1/18/24kris pastoriza questions to Eversource about structures 424, 212 and 356 and a repeatedrequest for the locations of the Category C poles.

## LINE X178-2/3 - LINE REBUILD

Structure 424 at right. Photos taken 3/17/24

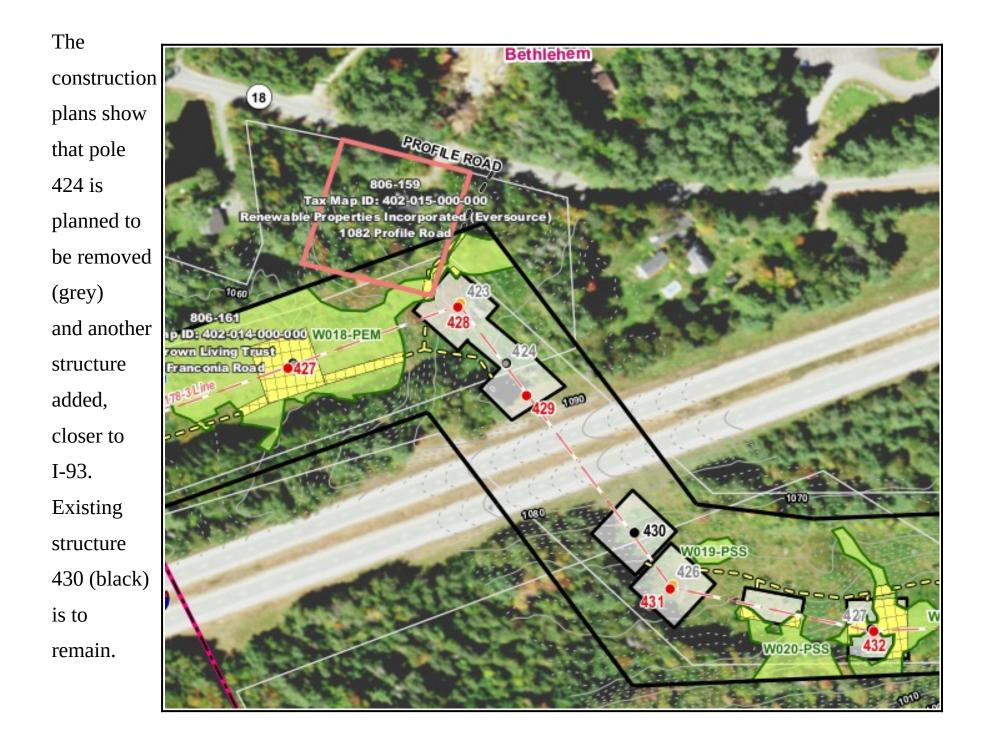
Structure 424 is a 1969 structure easily accessible from the property in Bethlehem that Eversource bought during Northern Pass.

-Structure 423 was recently replaced with a metal structure.

-You can see the former tangent structure 423 in the background:

-Why didn't Eversource proactively embrace efficiency and replace structure 424, or the pole, when it replaced structure 423?

-Was this 423 a

Category C structure that became Category D, and was replaced? Is this how Eversource used to manage the integrity of its structures? Is this how Eversource should be dealing now, with the maintenance of its structures?

There is no construction pad and the towers are quite short. Is this a temporary structure?

Are the metal poles constructed in two sections, allowing the upper section to be replaced with a taller one?

Because Eversource has refused for months to provide the existing and proposed structure heights sheets that were available for viewing at the public outreach meeting in Sugar Hill (8/2023) I am unable to comment on the apparent 37' height of this pole (or pole section?) but it is shorter than the vast majority of the existing structures.

Has Eversource's failure to cover its wood pole tops increased the rate of damage not only to the tops of its poles, but also the lower sections, by increasing water infiltration?

Is Eversource "proactive" in complete rebuilds, but not proactive in maintenance of its structures?

Structure 212 - Pole Top Rot & Rusted Hardware

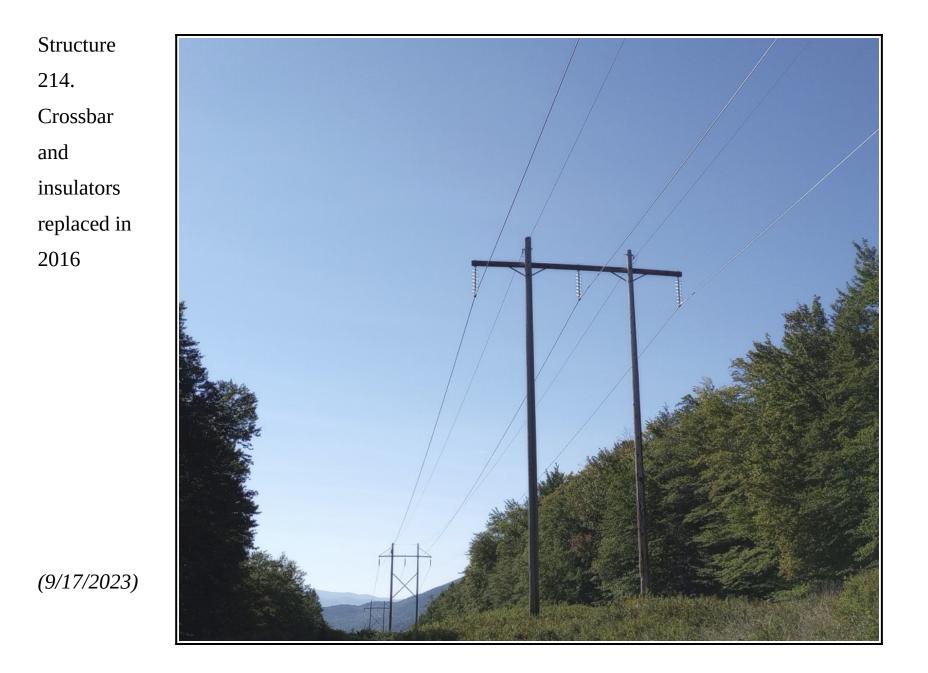
Eversource claims it needs to build a permanent road and construction pads here, in White Mountain National Forest, to access structure 212. Rusted hardware can be replaced. Why was this pole not covered when structures 214, 215 & 216 had insulators and crossbar replaced, via helicopter, in 2016?

Structure 215: Glass insulators are replacement insulators, along with the crossbars.

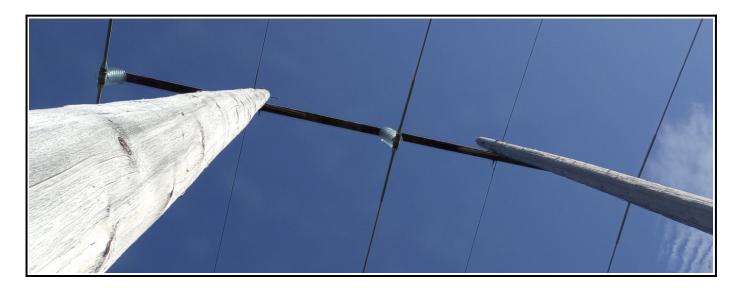
In the section of the

X-178 that is sited between Route 112, just west of North Woodstock and Bog Pond crossing, I have structures 196, 197, 198, 200, 220, 221, 223, 226, and 239 (of 193-247) also listed as having replacement cross-bars and insulators, work presumably all done in 2016.

Structure 216; right (all 9/17/2023)

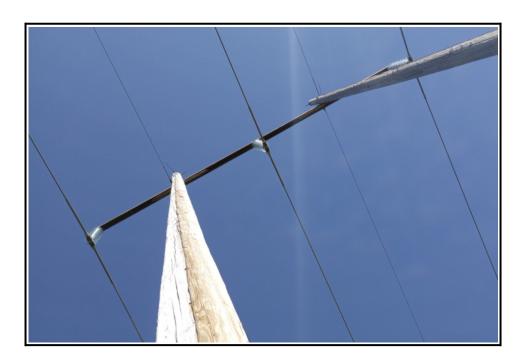
Crossbar and insulator replacement, X-178 line. Why didn't Eversource replace the 56 (in 2018) or 43 (now) Category C poles that needed replacement while it was doing this work? Was it waiting for them to become Category D? Have 13 of those poles/structures been replaced since 2018, as Category D poles?
